## BPW Transpec Answers to PBS Vehicles and Improved Roll Stability

05.082.14.43.2 (AO + AU)

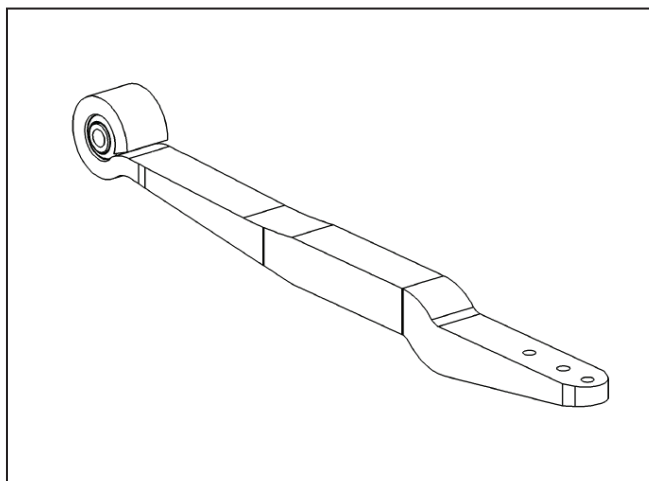
BPW Transpec has released two new spring trailing arms for AL2 air suspensions with improved roll stiffness ratings. The new spring trailing arms are 65mm thick rather than the original 62mm thick. This improves roll stiffness by at least 25%.

Original Spring	Replacement Spring	Use
1x62	1x65	
05.082.13.95.2	05.082.14.44.2	Already Standard in Australia
05.082.13.96.2	05.082.14.43.2	Available in 3-4 Months

These springs are available in the most common BPW suspension models currently available and can be substituted with no dimensional changes for the trailer builder.
